## **Redevelopment of MOD Bicester**

Addendum to Environmental Statement

April 2012

- 1.1.2 Each section of this report presents the responses to the questions raised by CDC under the same headings. Each section starts with the CDC questions followed by DIO's response. The number in brackets after each chapter heading refers to the number of the relevant query from CDC's Regulation 22 request.

**Figure 1**  
**Section Locations**

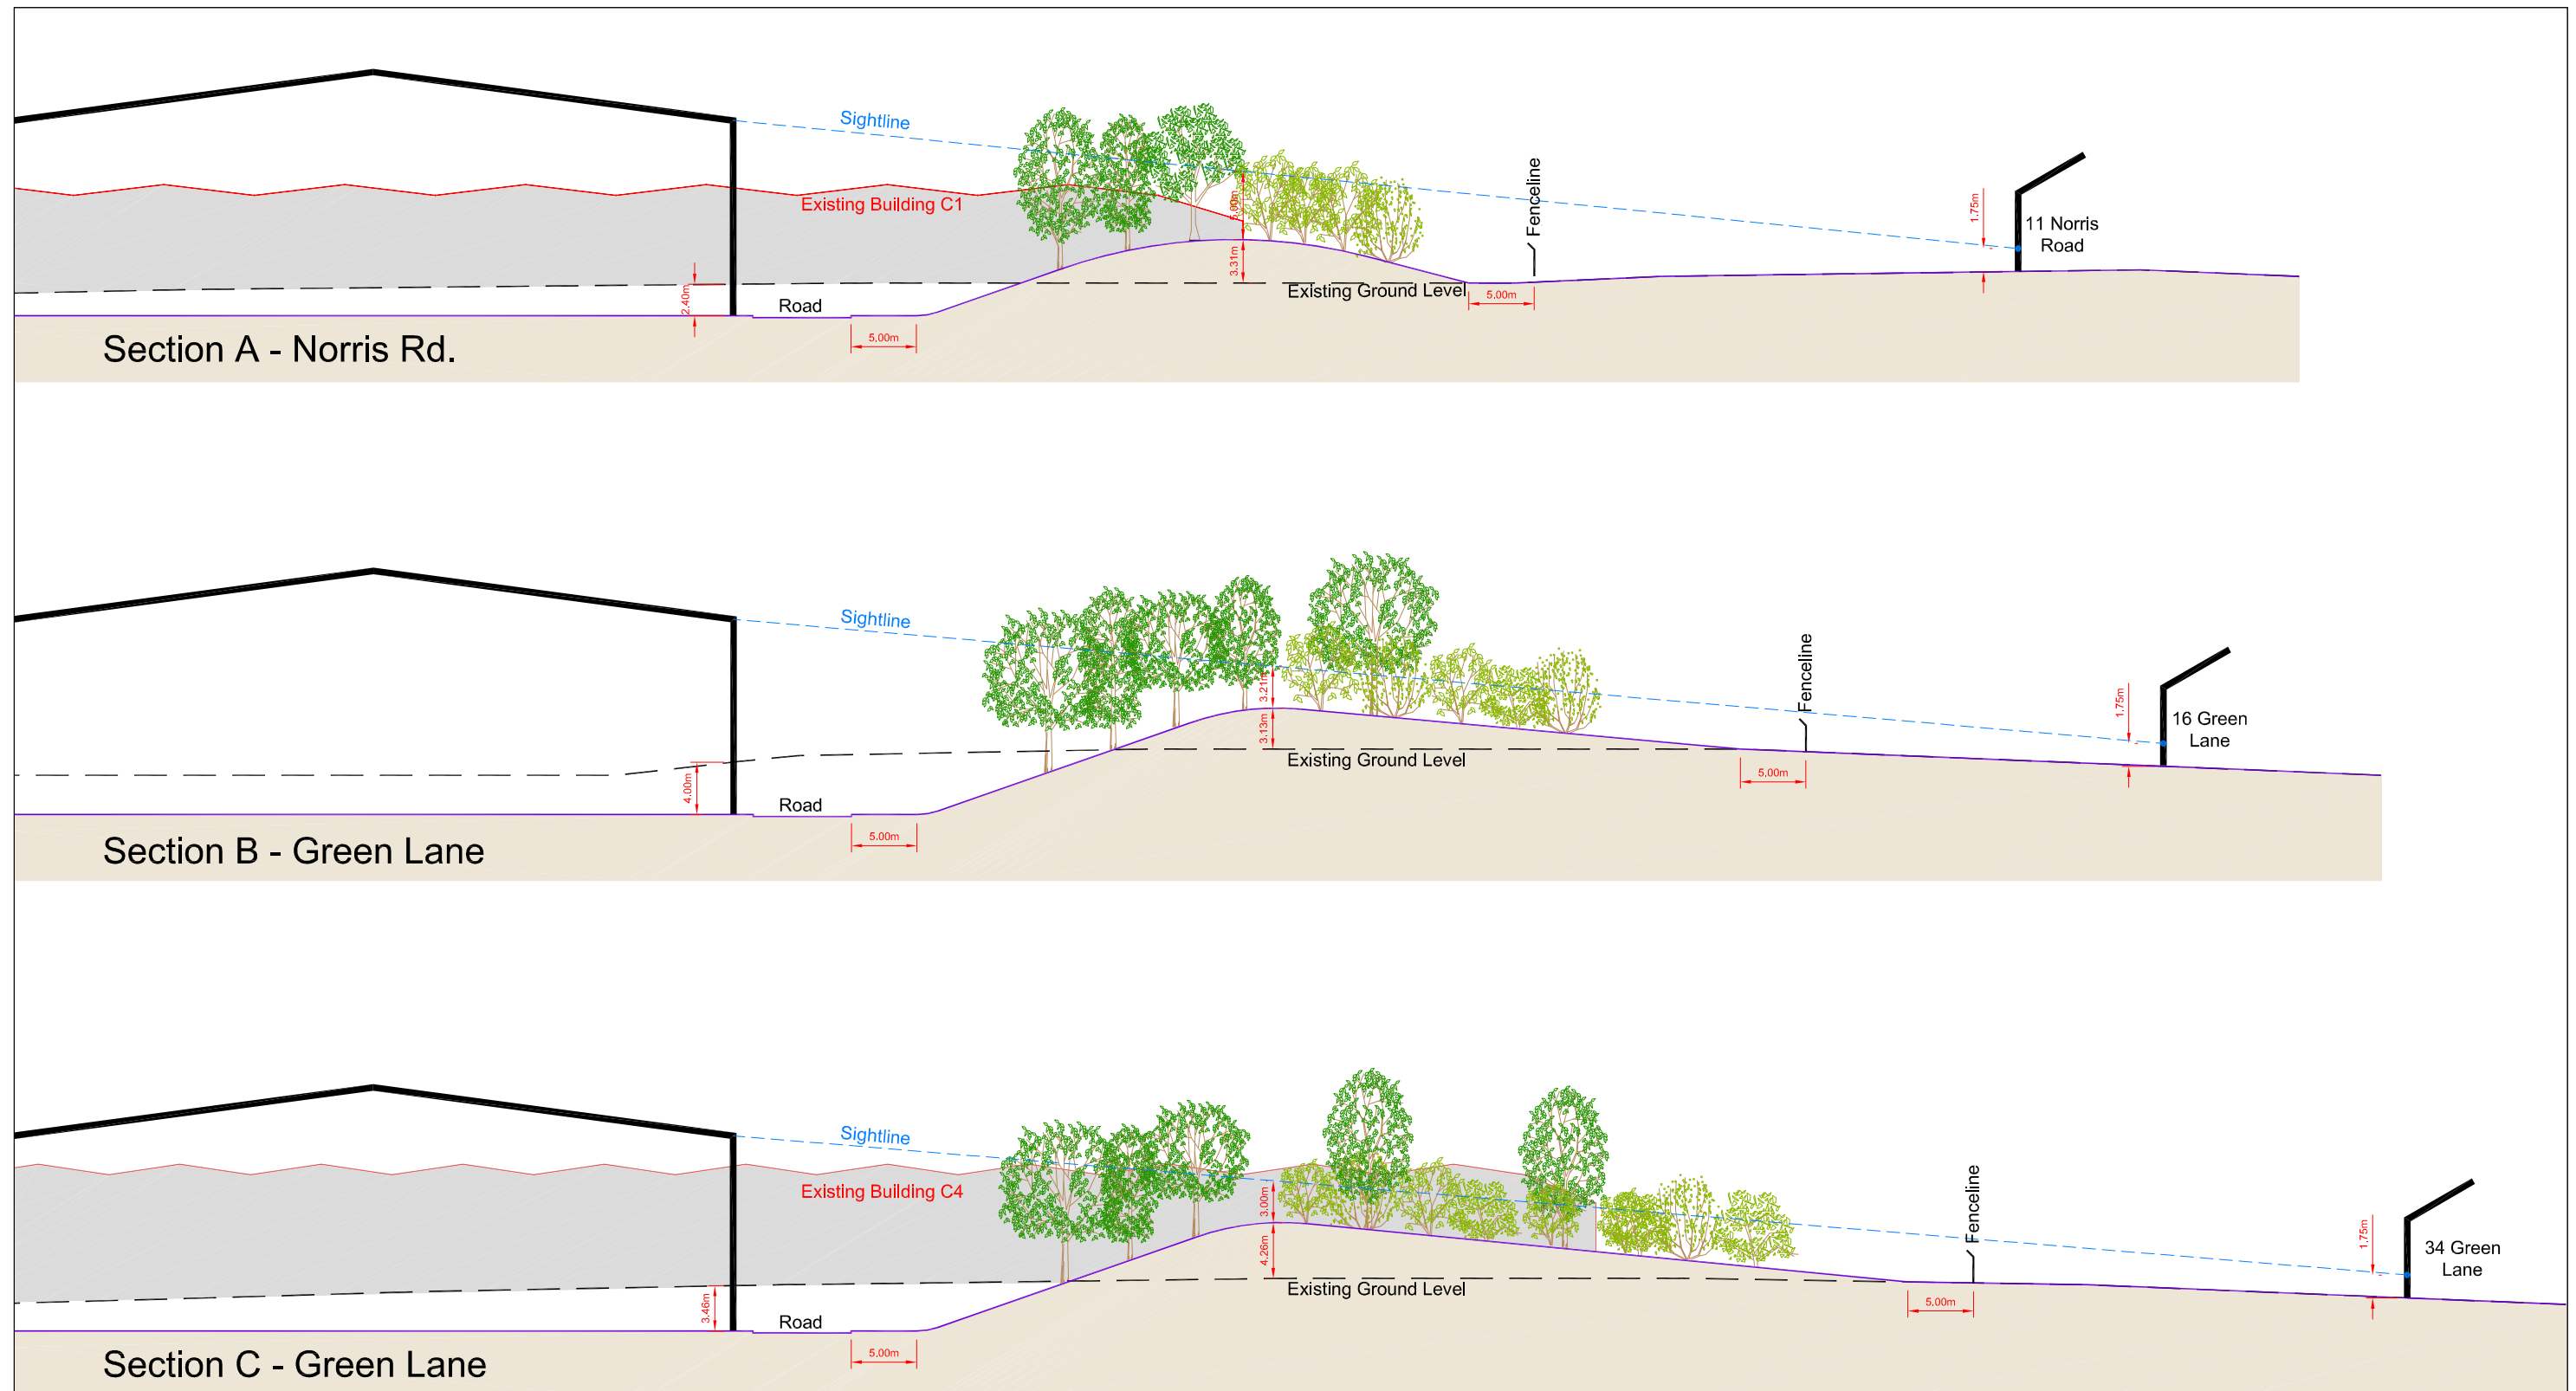
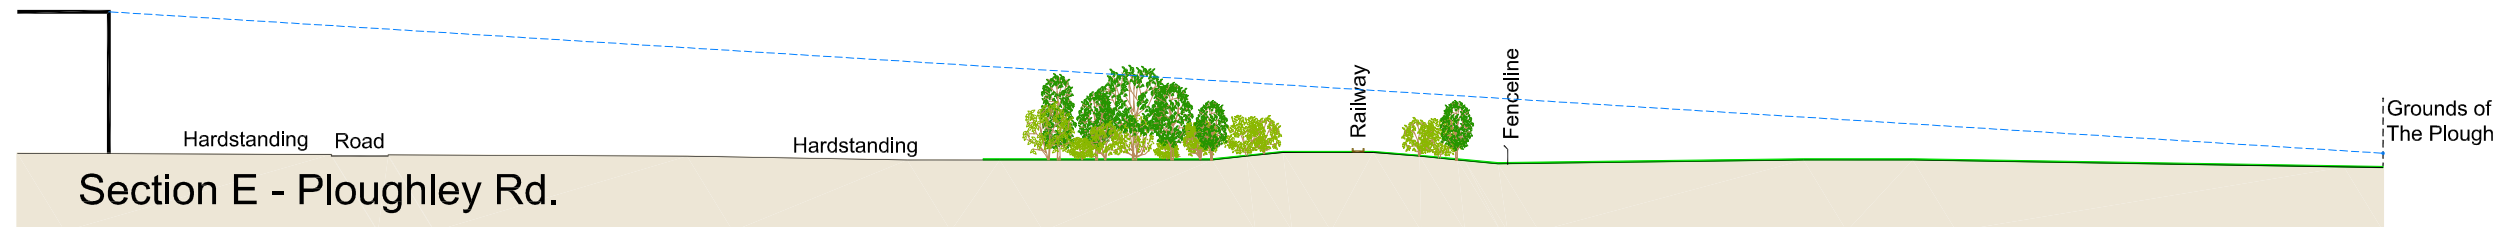
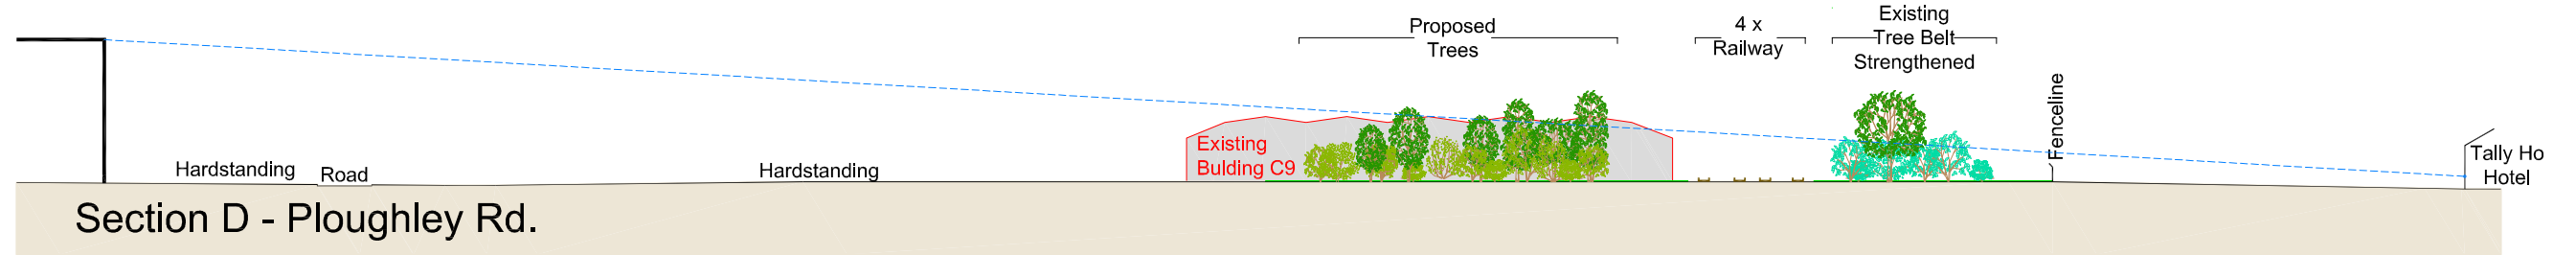
*“It is also proposed to provide some mounding 3.13-4.26m high. It is not clear where the mounding will be but I would assume it is in the areas of proposed woodland planting. This will help with the screening but won't reduce the actual height of the building. I estimate that the proposed building will be slightly lower than the height of the water tower, probably extending half way up the top tank. This provides a rough guide as to where the building will be seen from as the water tower is an important landmark on the site and easily identifiable from a distance”.*

- 6.2.7 The mounding locations are indicated on the attached Figure 1.
- 6.2.8 We agree the water tower is evident in wider views from the west; however, it is the existing buildings which are most prominent in the landscape, primarily due to their light colour, combined with the currently limited screening vegetation along the site's western boundary. The proposals include significant new screen planting to supplement that already in place. In addition, and in contrast to the existing development, significant opportunity exists to employ materials and finishes to the exterior of the new building that will reduce its visual and landscape effects.

**Figure 13**  
**C Site Wireframe Viewpoint 12**  
**0 Years Completion**

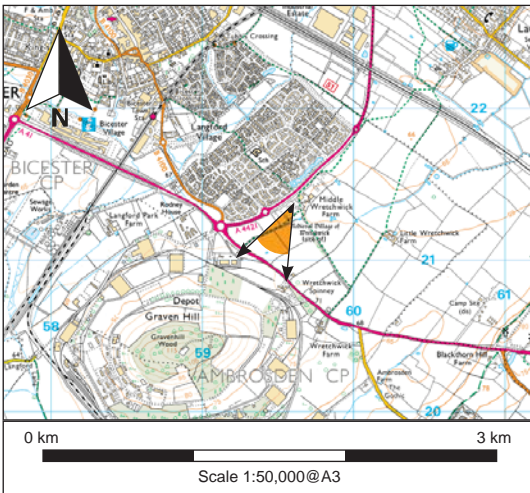
*"Viewpoint 12. The view from here is open due to very flat topography, no intervening features and lack of hedgerow planting. There is very little screening proposed so visibility will remain of a large dominant building".*

- 6.2.19 Screening will be improved as a result of additional planting on the site's western boundary. Subject to detailed design, screen planting width is estimated to be minimum 15m, widening significantly towards the south-west where additional space is available. Sufficient screening will therefore occur at maturity to increase the

beneficial 'filtering effect' from the public footpath. The widening of the screen planting to the south-west will increase this benefit. As indicated in Figures 11.45 and 11.46 of the ES, during construction and once construction is complete there is the potential for significant negative effects. However, once the planting has matured (estimated to take up to 15 years) significant adverse effects are unlikely (as indicated in the Figure 11.46).
